Office Action Summary

09/877,217

TSURUKAWA ET AL.

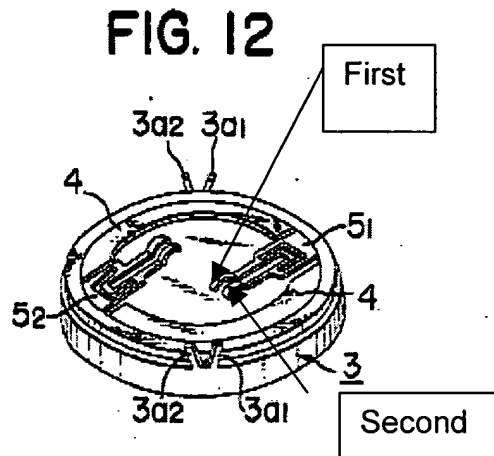
Aoki discloses in figures 1 and 2, a pair of electrode brushes (1) in which each pair of brushes (1) include a first and second separate portions (see figure below) in a

sliding contact with the contact electrode part of the commutator at respective sliding contact positions of a different distance from an axis of the rotation of the shaft (6) in order to reduce undesired noise by having a stable contact to between the brush and the commutator.
